JACKSON ROAD SIDEWALK PROJECT
BOARD OF COUNTY COMMISSIONERS
JACKSON COUNTY, FLORIDA
FDOT FPID # 438131-1-58-01
BID # 1617 Eng 12
ADDENDUM 2

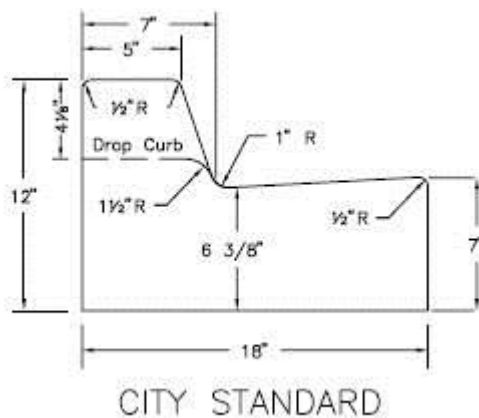
Question: Plans call for a Modified Type F Curb. Would the below drawing (for a curb machine mold) be a permissible design for use in locations calling for Modified Type F Curb?

Answer: Yes, this is the detail. But this curb is being placed beside an existing road, so I can't say whether or not your curb machine will be able to place the curb. My experience with curb machines has been that the curb was placed before the road was built.
